SEPT. 17, 1984

City and County of San Francisco

Arts Commission

A G E N D A

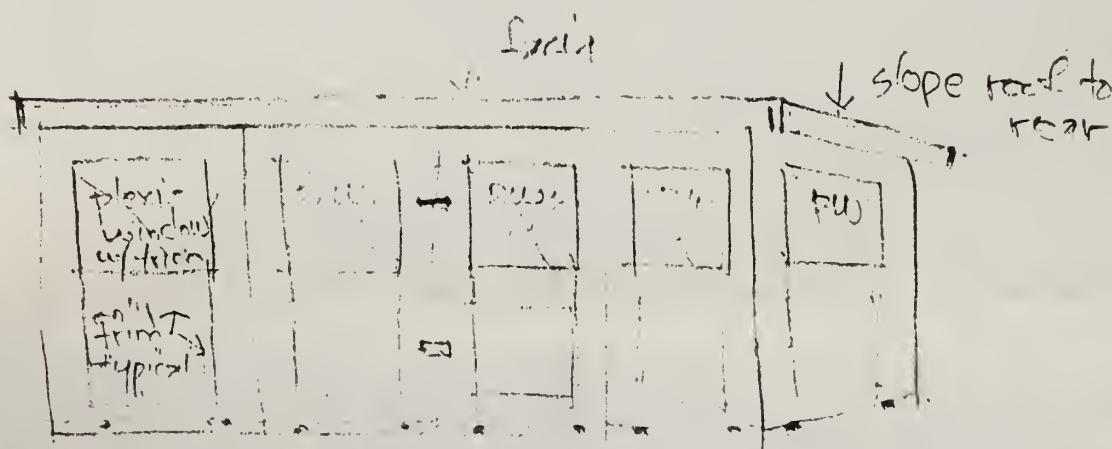
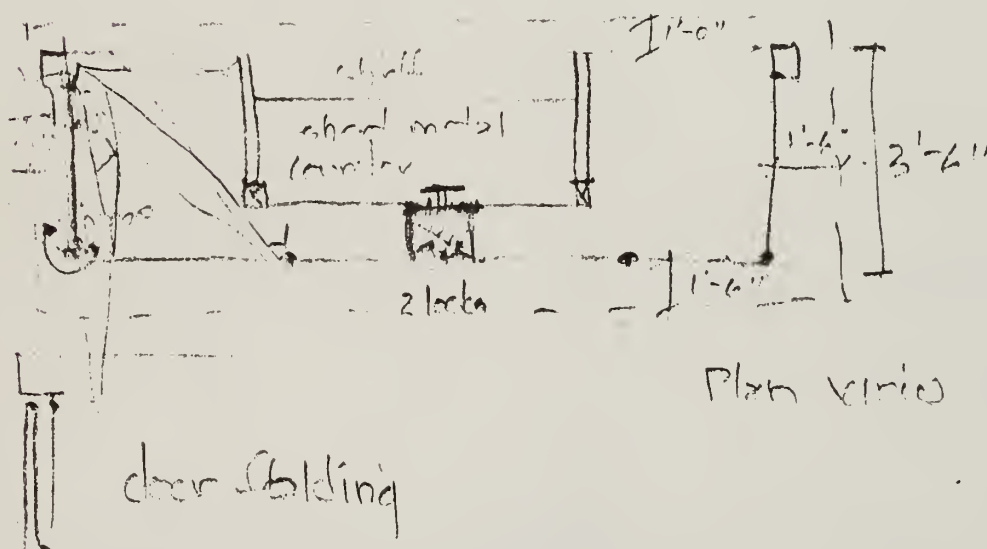
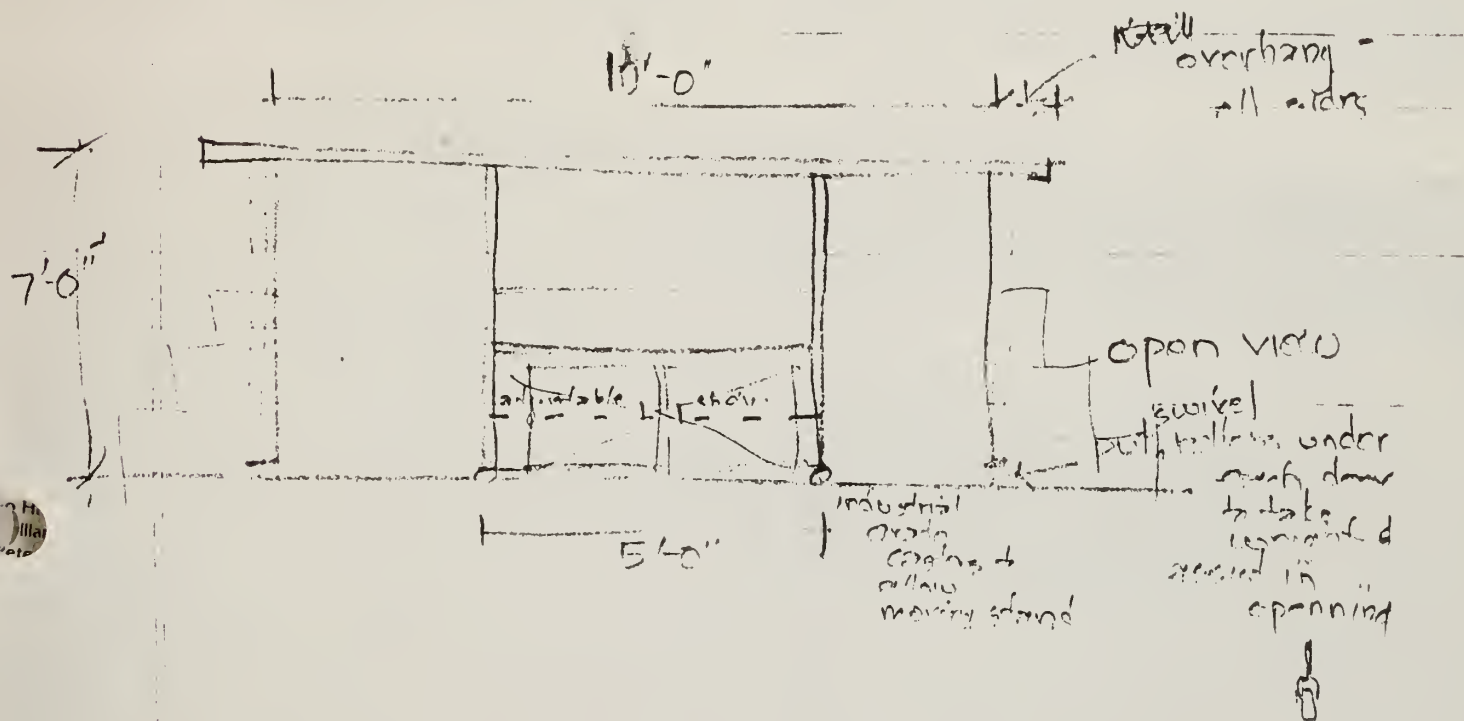
back - paint to match dark color of 901 -

also - use light color
